**PEA RIDGE PUBLIC SERVICE DISTRICT
CABELL COUNTY, WEST VIRGINIA**

CONTRACT #4 – ROUTE 2 SOUTH SANITARY SEWER EXTENSION

ADDENDUM #2

JULY 24, 2023

SHEET No.
10

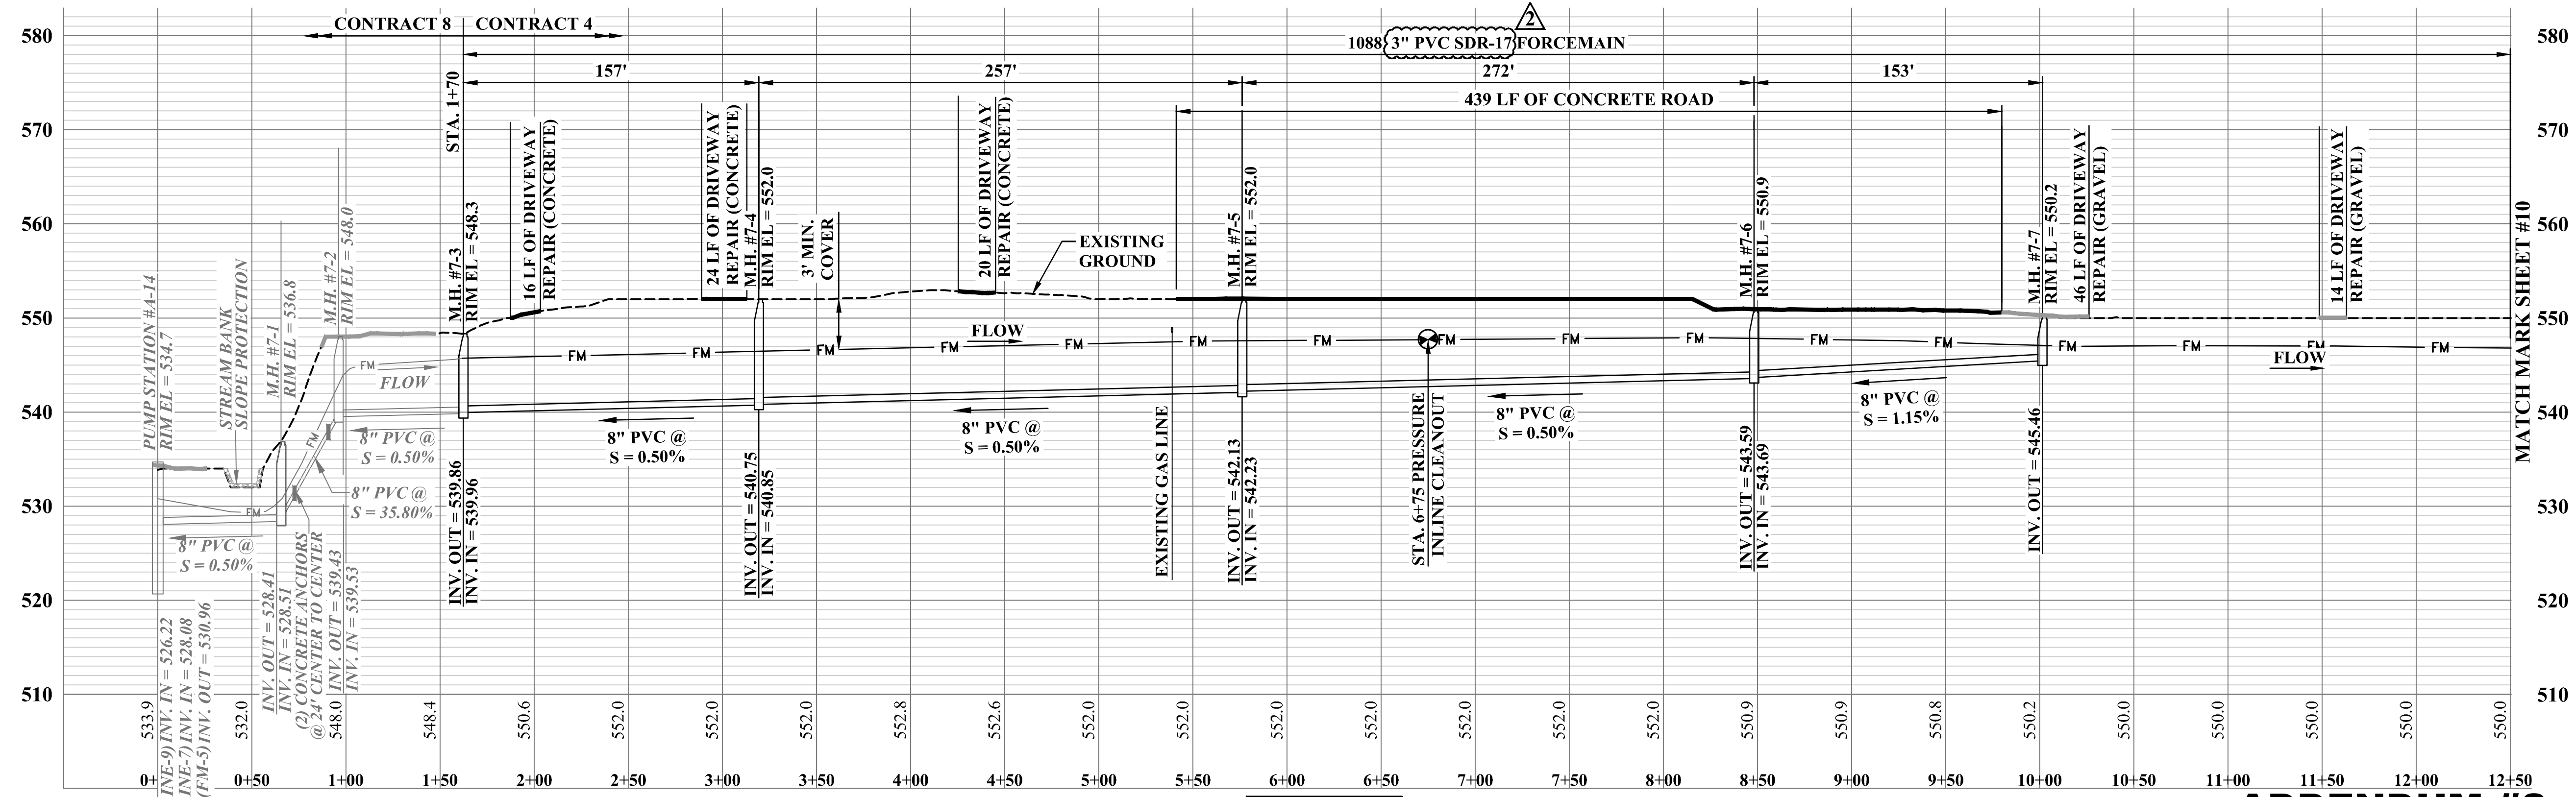
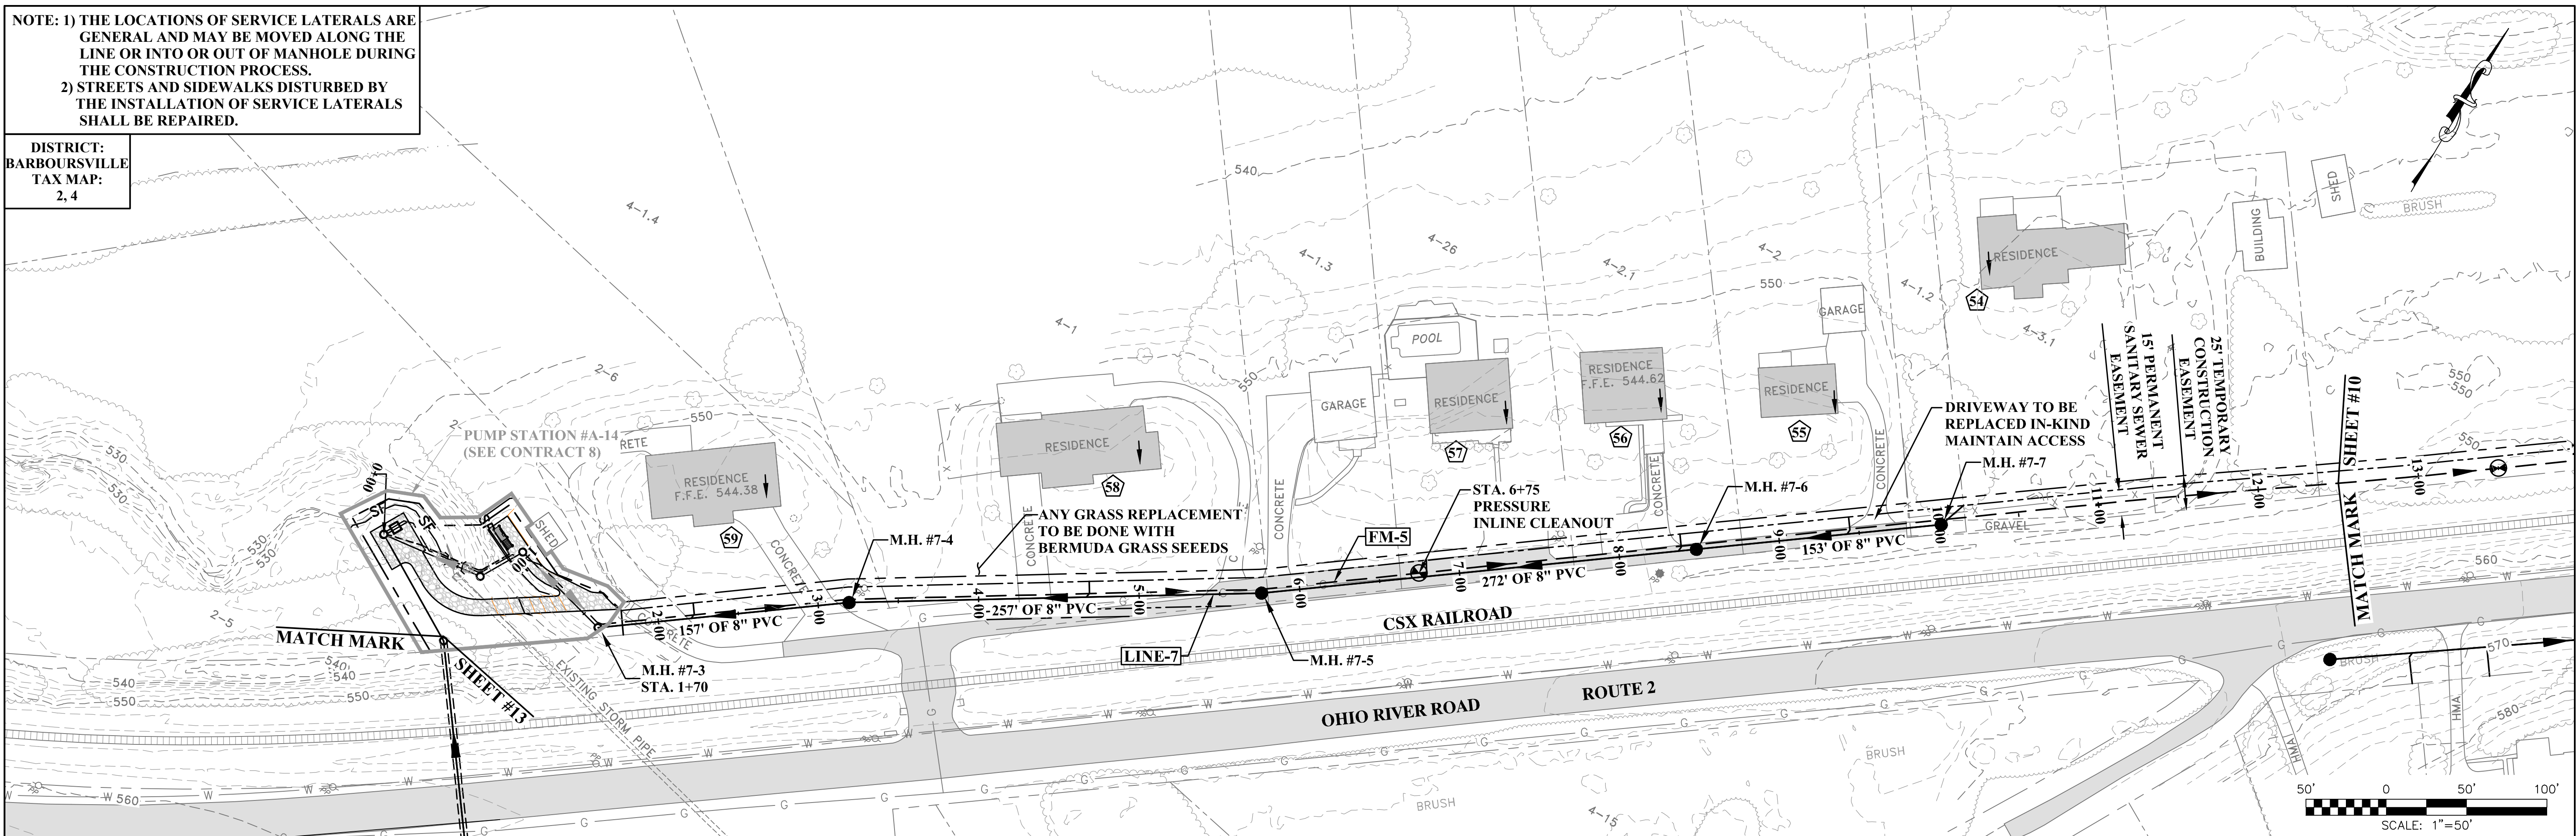
Will you add a bid item and detail for the 2.5" inline cleanout found on pages 8, 10, and 11 of the contract drawings?

The line size has been revised. A 2.5" to 3" cleanout is not needed.
